**Report to  
Development Permit Panel**

**To:** Development Permit Panel                    **Date:** May 11, 2004  
**From:** Raul Allueva                                **File:** DP 03-251106  
**Re:** Application by Patrick Cotter Architect Inc. for a Development Permit at  
10200, 10220 and 10222 No. 1 Road

2. 2004-06      **Multi-family Residential**  
*Patrick Cotter, Architect.*  
 10200, 10220, 10222 No. 1 Road  
 (Formal)

**PLAN 1 b**

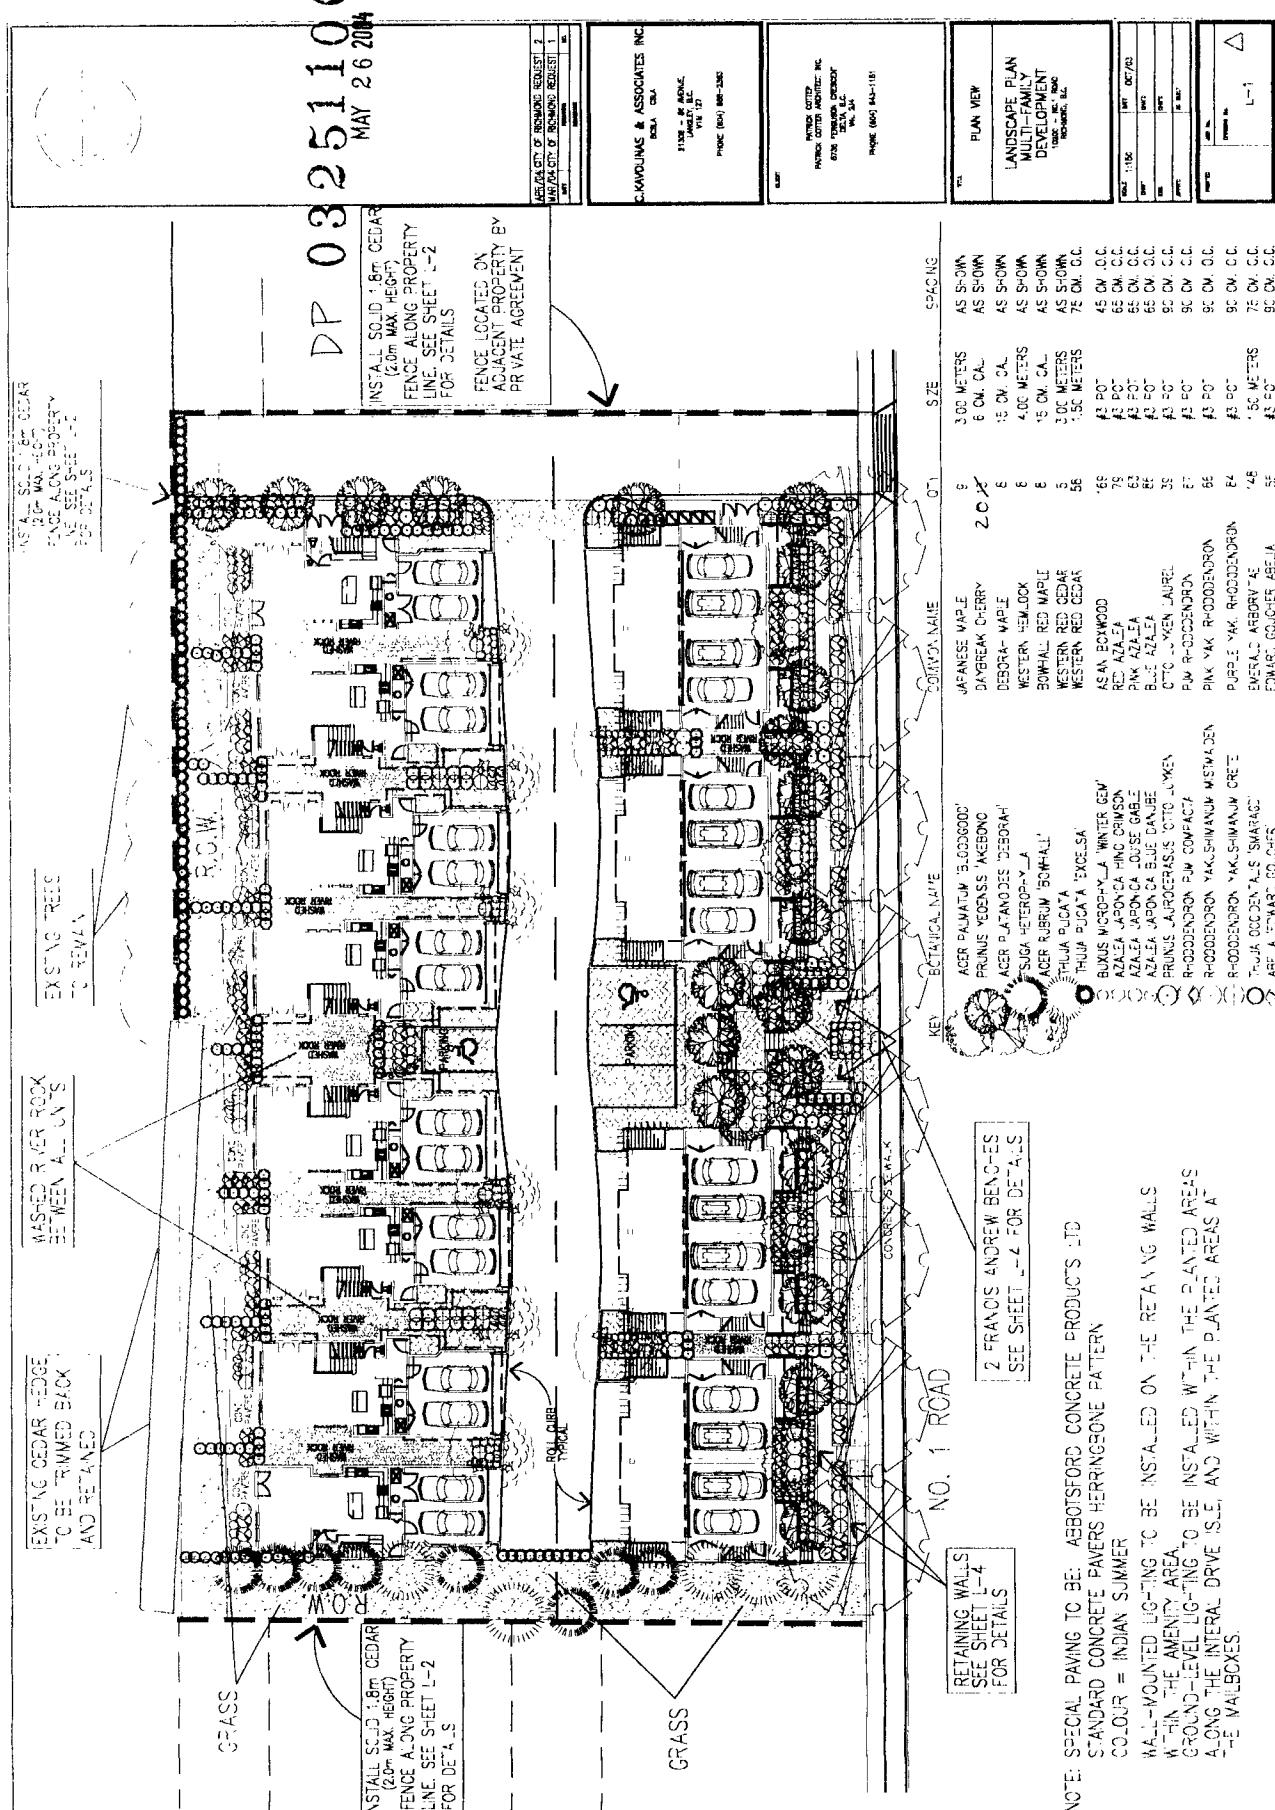
- 1) To vary the provision of Section 203(A).4 (Minimum Setbacks From Property Lines) to reduce the minimum required side yard setback from the lane dedication from 3 m to: 2.3 m for the southeast unit, 1.7 m for the electrical closet; 1.5 m for the southwest unit, 0.6 m for the recycling enclosure, and 0.9 m for the electrical closet respectively.

Variance Requested: \* A variance has been requested to permit the southeast unit and electrical closet; southwest unit, recycling enclosure and electrical closet to encroach into the required 3 m setback from the lane dedication. The proposed setbacks are as follows: 2.3 m for the southeast unit, 1.7 m for the electrical closet; 1.5 m for the southwest unit, 0.6 m for the recycling enclosure, and 0.9 m for the electrical closet respectively (see attached Plan #1).

*(Staff supports the proposed variances, as they are considered minor, and are the cumulative result of the substantial road access requirements on the site, resulting in the applicant granting both a public right-of-way for public passage and a lane dedication. The variances also reflect a site layout which attempts to mitigate the impact of this development on the single-family homes to the east by creating individual units that resemble single family lots, thus requiring separation of units and affecting the side yard setbacks)*
